Access Compliance Report

Public Rights-of-Way

(Curb Ramps)

Intersection ID: 15267	Main Street: EAST_BV	Cross Street: FLORAL_AV	Location: SW
ADA ID: 71E86A538DF0	Ramp Type: Perp	Initial Pass/Fail: Fail	Overall Compliance: No
Severity Score: 37.5			
Codes/Mitigation Info/Possible Solution		Field Measurements/Component Compliance

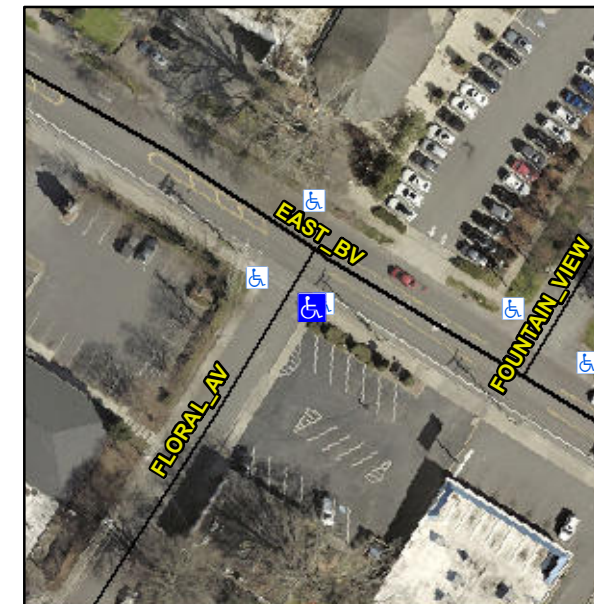
Not Found, R304.2.2, R304.5.3

Compliance	Description	Data	Compliance	Description	Data
N/A	Ramp Length (in)	60.0	No	Ramp Slope (%)	9.5
Yes	Ramp Width (in)	48.0	No	Ramp XSlope (%)	10.0
N/A	Flare Type LT	N/A	N/A	Flare Type RT	N/A
N/A	Flare Slope LT (%)	N/A	N/A	Flare Slope RT (%)	N/A
N/A	Flare Traversable LT?	N/A	N/A	Flare Traversable RT?	N/A
N/A	Landing Length (in)	N/A	N/A	DWS Provided?	N/A
N/A	Landing Width (in)	N/A	N/A	DWS Contrast?	N/A
N/A	Landing Slope (%)	N/A	N/A	DWS Length (in)	N/A
N/A	Landing X Slope (%)	N/A	N/A	DWS Full Width?	N/A
N/A	Landing Curb? (Y/N)	N/A	N/A	DWS Offset (in)	N/A
N/A	Shared Landing?	N/A			
N/A	Gutter Ponding?	N/A	N/A	Gutter Slope (%)	N/A
N/A	Gutter Lip Ht (in)	N/A	N/A	Gutter X Slope (%)	N/A
N/A	Painted X Walk1?	No	N/A	Painted X Walk2?	N/A
	X Walk 1 Direction	To NW		X Walk 2 Direction	N/A
N/A	X Walk 1 Width (in)	N/A	N/A	X Walk 2 Width (in)	N/A
	X Walk 1 Slope (%)	6.3		X Walk 2 Slope (%)	N/A
	X Walk 1 X Slope (%)	2.8		X Walk 2 X Slope (%)	N/A

Remove & Replace Entire Ramp.
